TECHNICAL SERVICE BULLETIN

Classification: EM22-005	Reference: NTB22-096	Date: November 2, 2022
-----------------------------	-------------------------	---------------------------

LOSS OF POWER, ENGINE NOISE, AND/OR BATTERY LIGHT ON

APPLIED VEHICLES: 2020-2021 Sentra (B18)

Figure 1

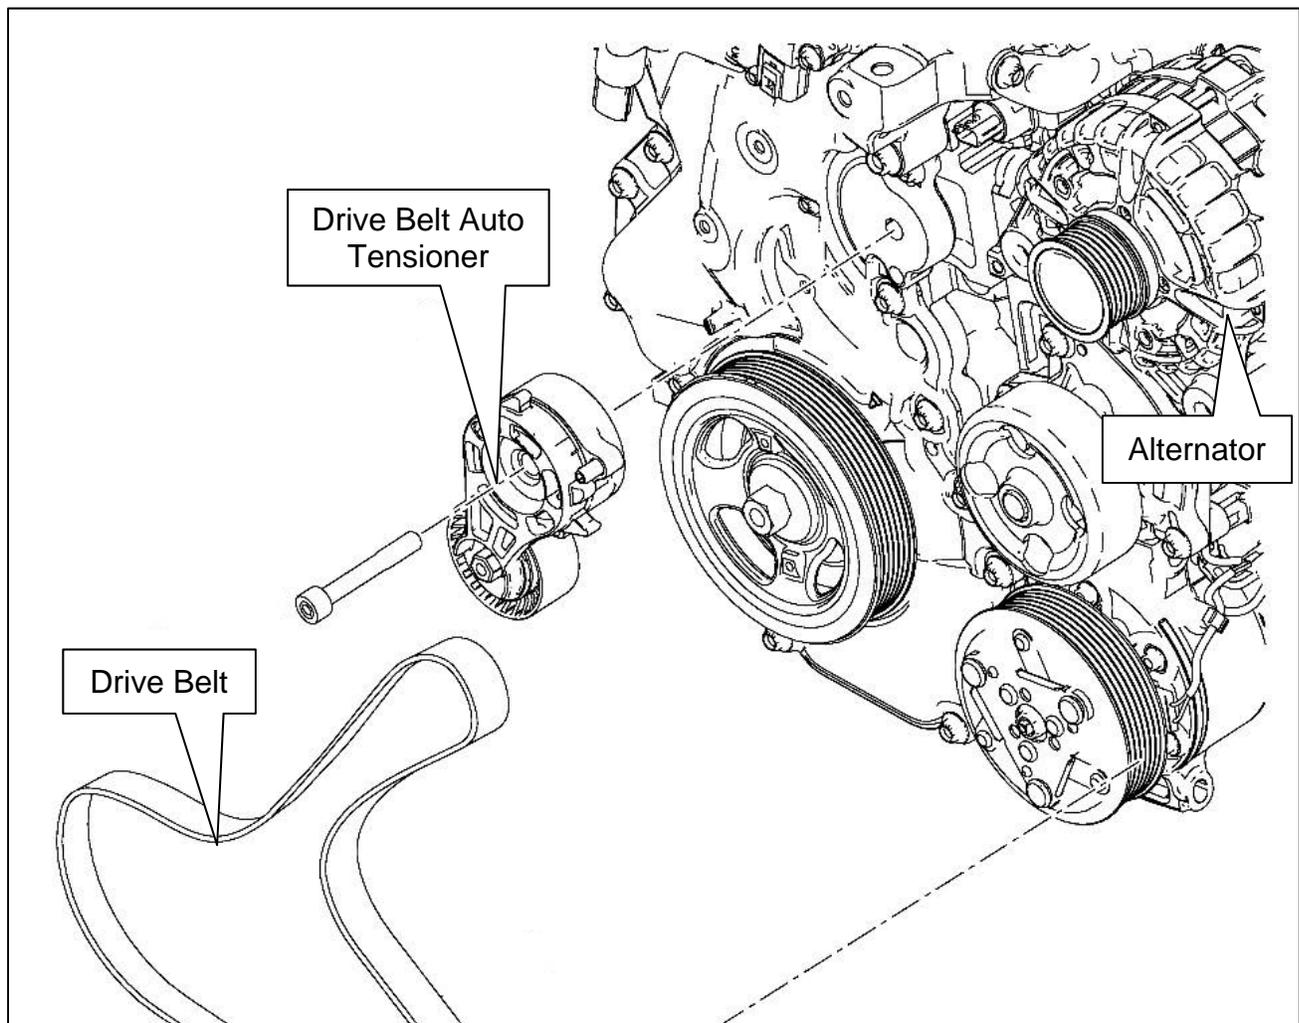
1. Replace the Alternator, the associated Drive Belt, and the Drive Belt Auto Tensioner (Figure 1).
